Item Name: Fwd Crosstube - Mid Height 206L / L1 / L3 / L4, Blue

DART AEROSPACE LTD		Work Order:	162192
Description: Crosstube Mid Fwd (206L)		Part Number:	D206-667-107
Inspection Dwg: D206-667-147 Rev: A		Page 1 of 1

DESIGN		DART AEROSPACE LTD	
DRAWN		HAWKESBURY, ONTARIO, CANADA	
CHECKED		DRAWING NO.	REV. A
MFG. APPR.		D206-667-147	SHEET 4 OF 4
APPROVED		TITLE	SCALE
DE APPR.		CROSSTUBE ASS'Y (206L MID FWD)	NTS
DATE	10.12.23	COPYRIGHT © 2010 BY DART AEROSPACE LTD THIS DOCUMENT IS PRIVATE AND CONFIDENTIAL, AND IS SUPPLIED ON THE EXPRESS CONDITION THAT IT IS NOT TO BE USED FOR ANY PURPOSES OR COMMUNICATIONS TO ANY OTHER PERSONS WITHOUT WRITTEN PERMISSION FROM DART AEROSPACE LTD.

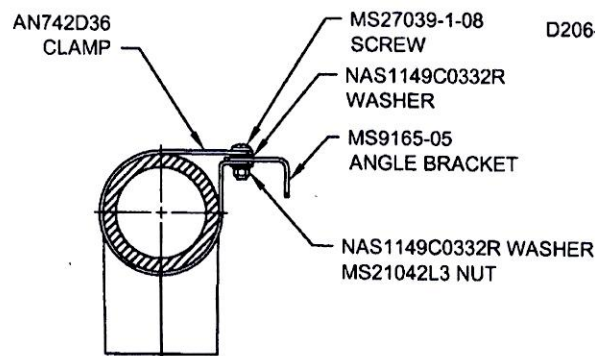
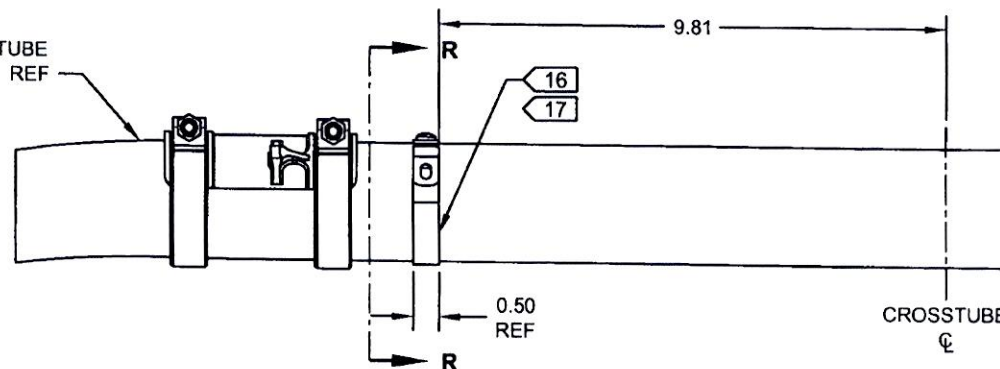
PURPOSE:

ADD ELECTRICAL GROUNDING STRAP

ITEM	QTY -147	PART NUMBER	DESCRIPTION
1	X	D206-667-147	CROSSTUBE ASSEMBLY (206L MID FWD)
10	2	AN742D36	CLAMP
11	2	MS9165-05	ANGLE BRACKET
12	2	MS21042L3	NUT (OR MS21042-3)
13	2	MS27039-1-08	SCREW
14	4	NAS1149C0332R	WASHER (OR AN960C10L)

- 16) MASK AREA UNDER CLAMP PRIOR TO PAINTING
- 17) SEAL EDGES WHERE AN742D36 CLAMP MEETS WITH THE CROSSTUBE USING SIKAFLEX-241/-291 OR MIL-S-8802 CLASS B2 OR PROSEAL 890 SEALANT
- 18) PERFORM RESISTANCE CHECK TO ENSURE MAX RESISTANCE IS 10 MILLIOHMS

DETAIL P
BONDING STRAP INSTALLATION 2 PL
